WRITTEN REPRESENTATIONS

Submission to ExA 30th January 2023

Angela Carter & Antony Carter A12C-AFP259

10. Fig 2: DEFRA Lden Noise Mapping round

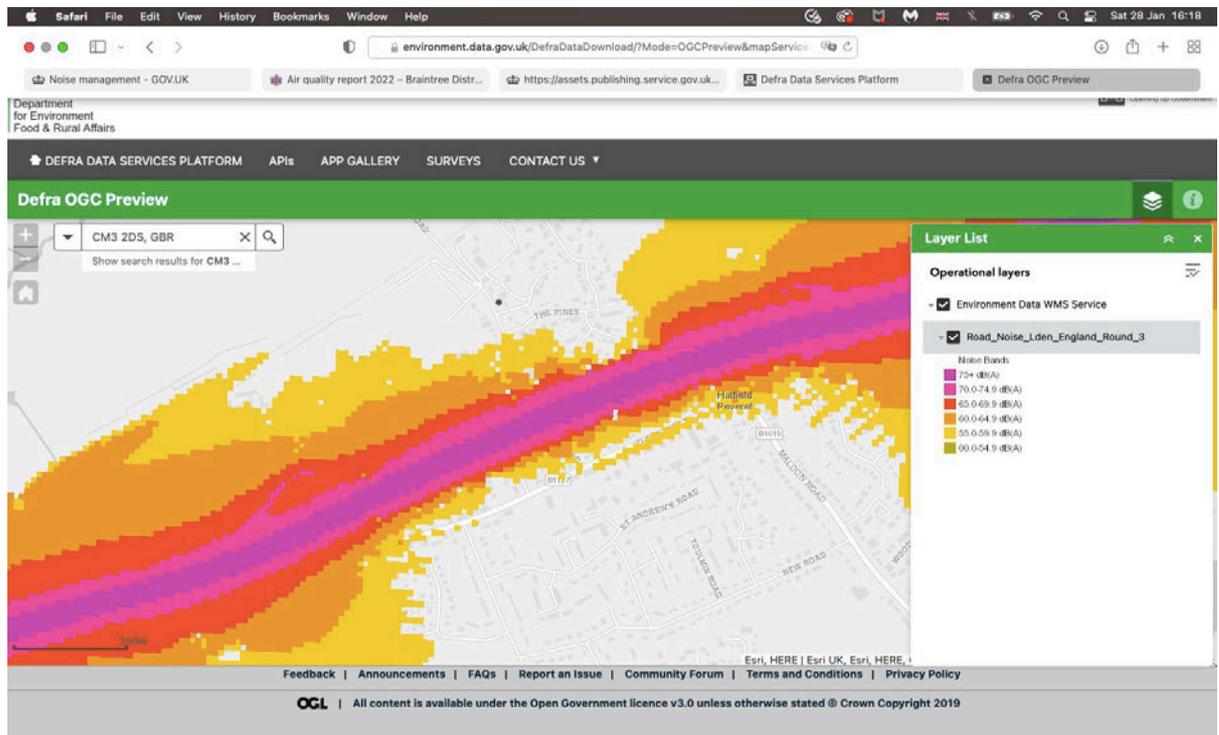
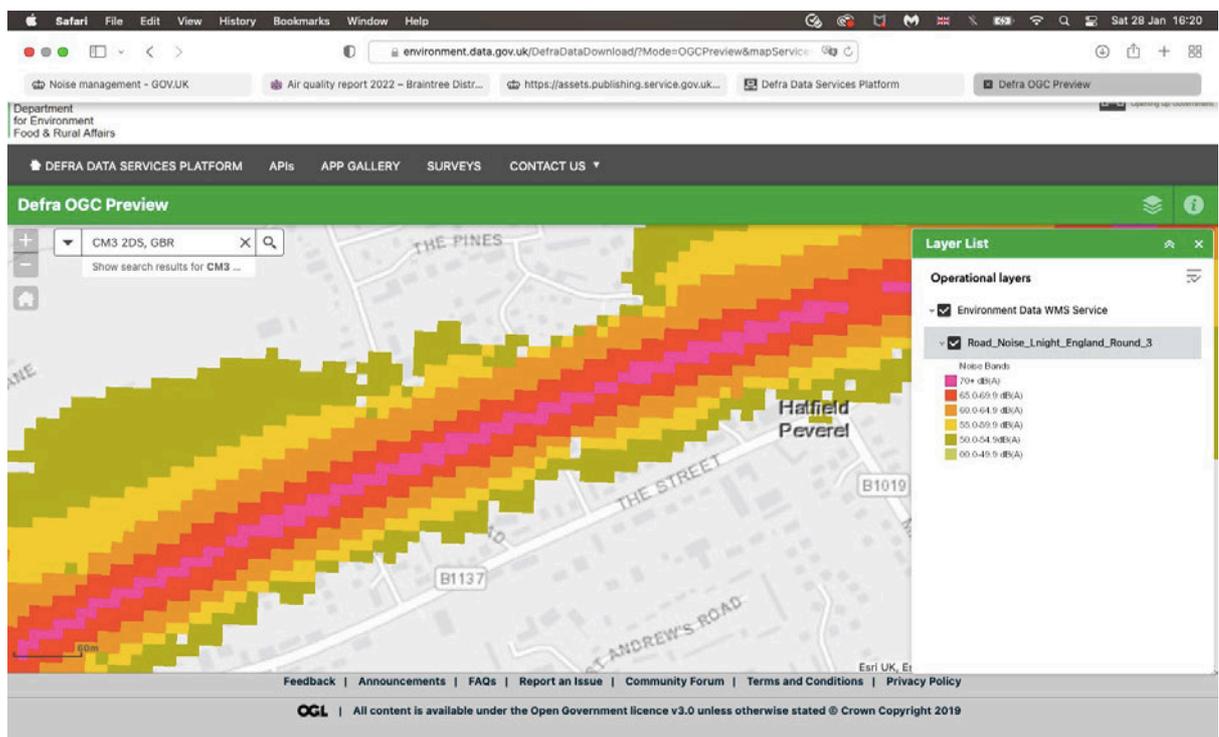
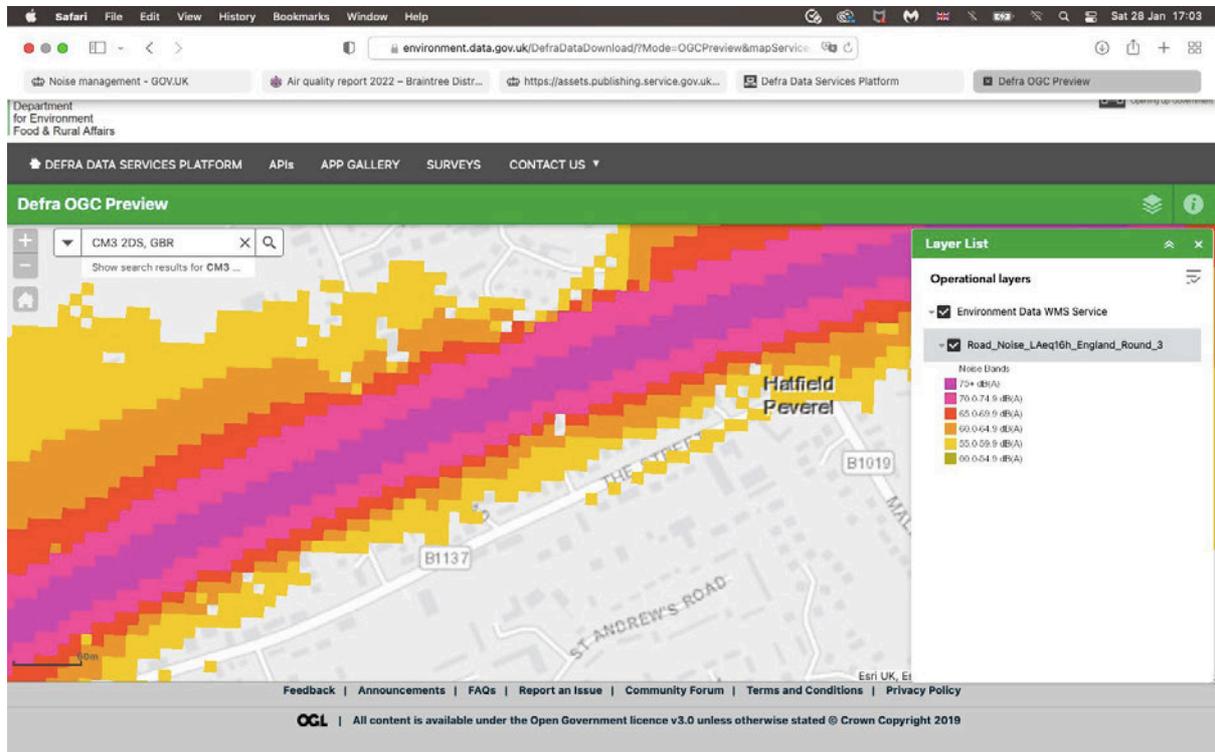
15. As Fig 1 to Fig 4 show; for properties at the top of the embankment, both south and north, the receptor walls fall within the noise range of Lden 70-74.9dB(A) and borderline between Lnight 65 - 69.9dB(A) & Lnight 60.0 – 64.9dB(A). The centre of the postcode CM3 2DS on Station Road shows average range of noise pollution to be within Lden 60.0-64.9dB(A). Marina Close shows a constant exposure average of Lden 60.0-64.9dB(A) and Rookery Close shows an exposure of Lden 55.0-59.9dB(A)

22. These measures will, de facto, increase the dB(A) Lden & dB(A) LAeq16h & Lnight of the residences along both embankments beyond these levels and runs counter to the Noise Reduction Plan (Roads) 2019 unless multi-layer noise mitigating measures are implemented.

24. **Fig 7.** Showing planned removal of vegetation on embankment between Station Rd Bridge & Wellington Bridge(B1019)

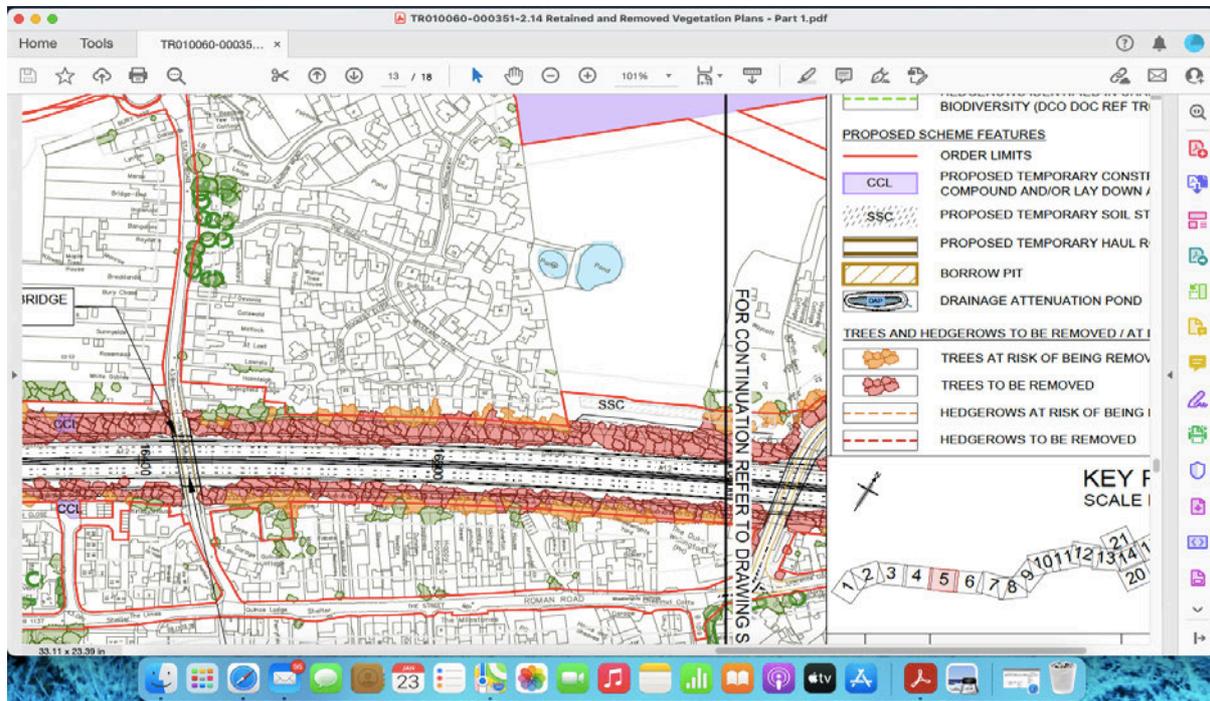
23. It is also proposed that prior to construction taking place the vegetation along the embankment will be removed. Whilst this is an obviously sensible measure it will increase the noise level significantly. I can find no satisfactory mitigating measures in the applicant’s application for the DCO. This will take years to replace.

is greater during these seasons as the road surface is generally wet. I suggest that there are enough native evergreen plants to facilitate improved screening and noise reduction by planting them instead of the deciduous varieties. They would also improve combatting air pollution.
